# FLIGHT READINESS STATEMENT
# STS-76/ET-77 AND STS-77/ET-78
# Δ EXTERNAL TANK PROJECT REVIEW

**EXTERNAL TANKS ET-77 AND ET-78, AS IDENTIFIED IN THE EXTERNAL TANK PROJECT DELTA FLIGHT READINESS REVIEW DATED FEBRUARY 28, 1996, ARE CONSIDERED READY TO SUPPORT FLIGHT UPON ACCEPTABLE DISPOSITION OF OPEN WORK AND/OR OPEN ACTIONS.**

# STS-76/ET-77
# STS-77/ET-78
# Flight Readiness Review

**Forward ET/SRB Attach Fitting**

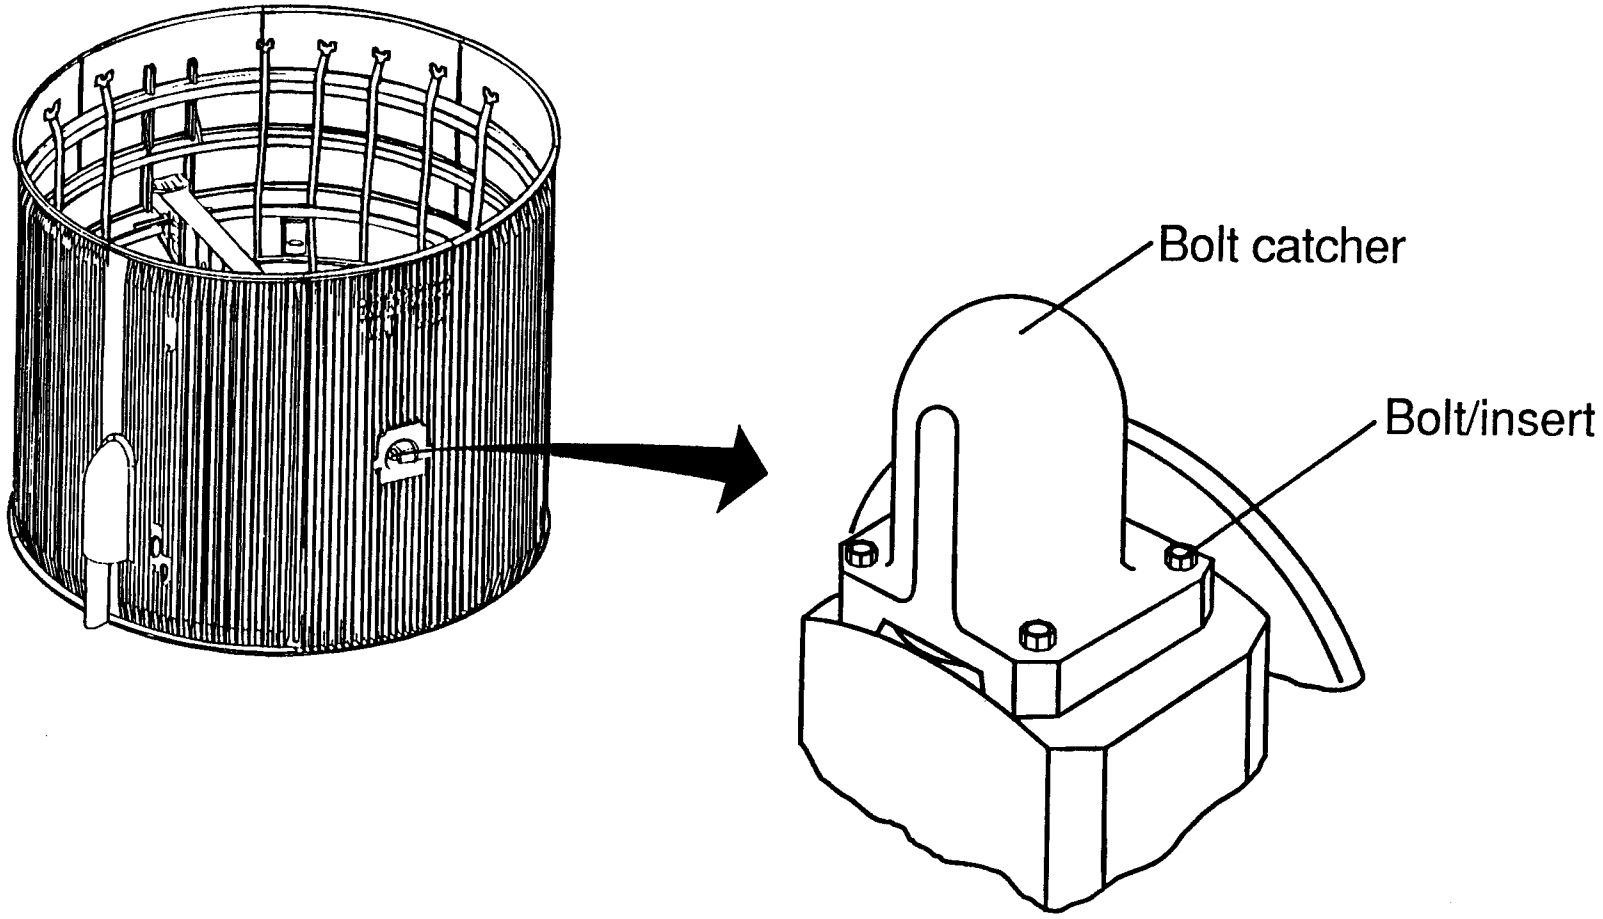
- Hardware
  - Replace 4 non-locking inserts which secure the forward SRB bolt catchers with self-locking inserts
  - Eliminate use of Locktite locking compound
- Requirements
  - Revised ICD-2-24001, CIL, and HCSs to reflect change

- Non-locking inserts used due to repeated installations early in program
- Current Launch processing has eliminated the need for repeated installations
- Elimination of Locktite enhances hardware processing flow at KSC

- Stress analysis - Bolt and insert strength remain unchanged
  - Critical FS = 17.7 (tension, bending and shear)
- Bolt retention equal to or greater than installation with Locktite

**LH2 tank forward dome (looking aft)**

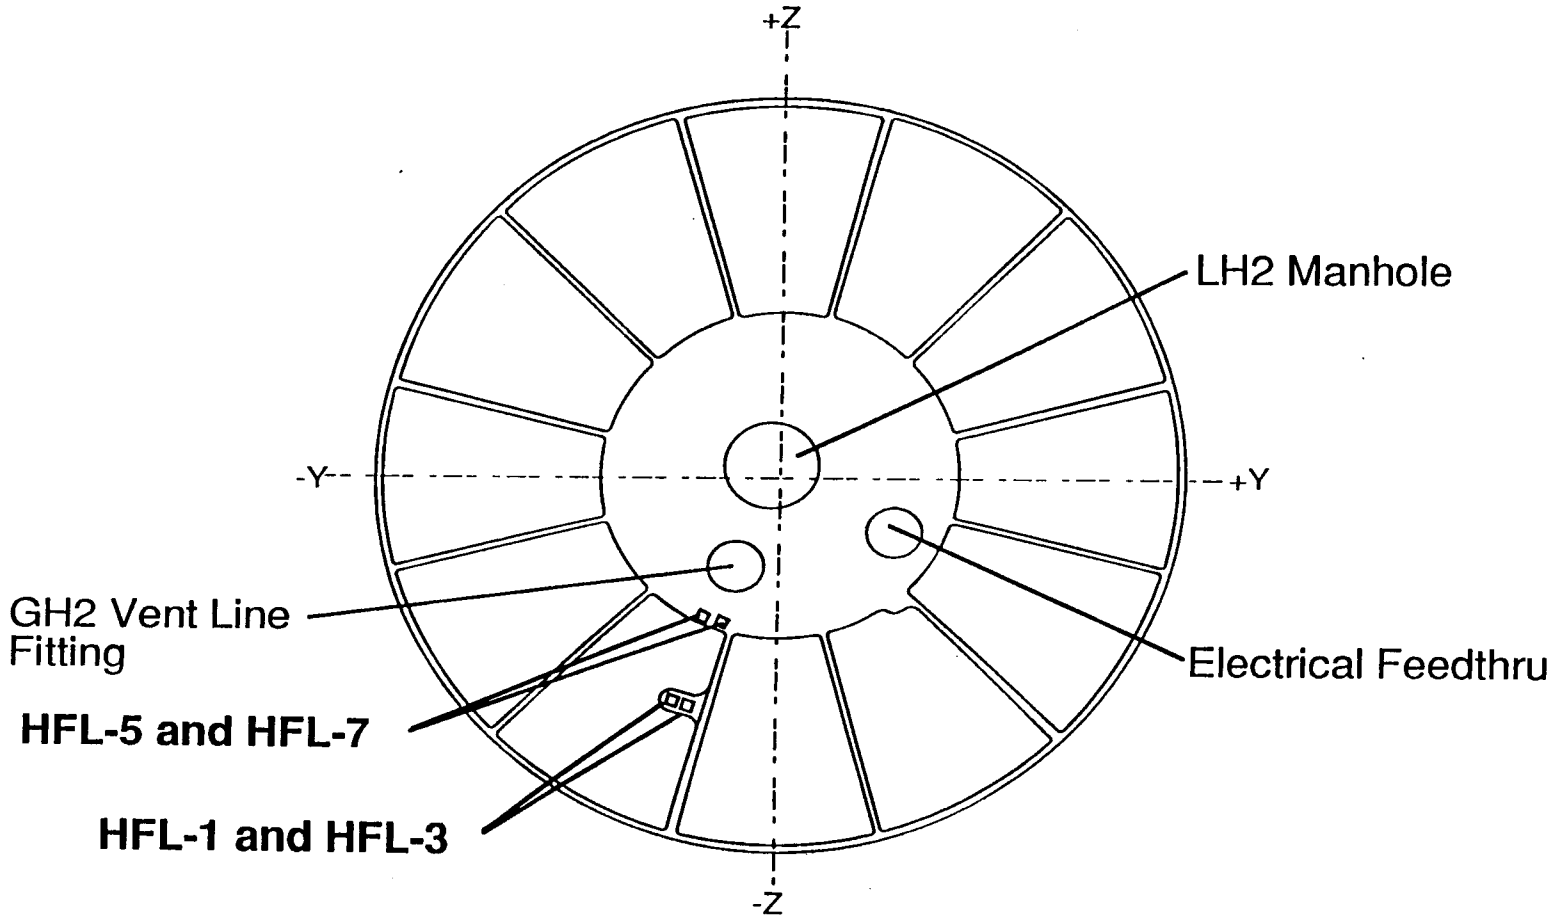
- LH2 dome lug fillet welds (HFL-1, -3, -5, and -7) resulted in "suck-back" (weld bead depression) defects during manual TIG weld

- All areas heat repaired from the outside
  - All areas acceptable except HFL-1
  - Pre-proof X-ray showed 0.150" crack in HFL-1 after initial repair
    - Reduced to 0.050" by additional heat repair
- Leak check in Bldg 451 was acceptable
- Post-proof X-ray results:
  - Acceptable welds on HFL-3, -5, and -7
  - Unchanged 0.050" crack on HFL-1
  - Detected additional 0.175" crack on HFL-1

- Improperly executed manual weld
  - Weld process is extremely operator dependent

- HFL-1 cracks - Use as is
- Suck back repaired on all welds

- Stress analysis: Critical FS of as welded configuration unaffected
  - Tensile test of test specimens verified that allowables were conservative
- Fracture analysis of detected linear indications in HFL-1: 15 missions to leak, 40 missions to burst for 0.175" defect
  - Conservative flaw size assumptions
  - Conservative stresses applied to growth of crack
  - Flaw size and fatigue life within database
- Visual and penetrant inspection and post-proof leak check acceptable
